THE GLIDING FEDERATION OF AUSTRALIA

AIRWORTHINESS DIRECTIVE GLIDER/POWERED SAILPLANE

GFA/AD 228

SUBJECT: Inspection of attachment of wing centre section to Frame 6.

T53 WING CENTRE SECTION JOINTS TO FRAME 6

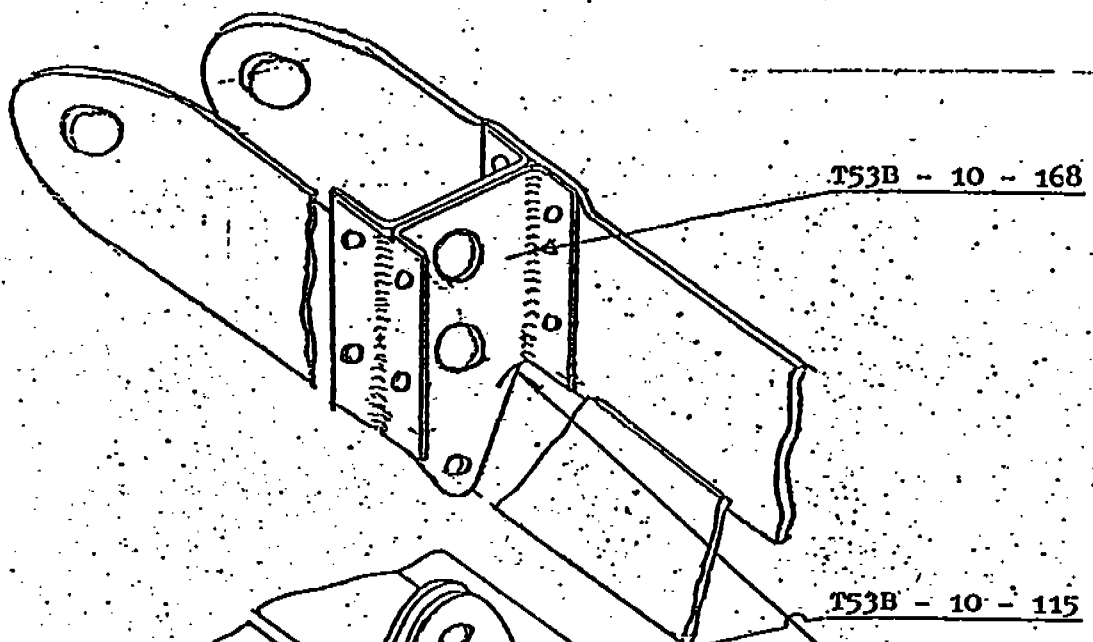
Remove glass fibre fairing No. T53B-10-1093 and wings if fitted. Using a Dye penetrant crack detection system, inspect for cracks at the corner of the fittings where the attachment flanges begin (a) the welded brackets Pt No. T53B-10-168 issue 1-4 see figure 1 page 2 which holds the rear spar member of the c/s to the fuselage frame 5 and (b) the alternative riveted bracket Pt No. T53B-10-168 issue 5. Also in a similar manner inspect the metal lugs T53B-10-115 and channel section T53-10-118 on frame 6. See Figure 2. Checking for cracks in way of rivets.

If any cracks are found the aircraft is to be grounded. All findings to be reported to CTO/A G.F.A. New components can be obtained from S.E.L. if required as listed above. If there are no cracks the aircraft is cleared for flight.
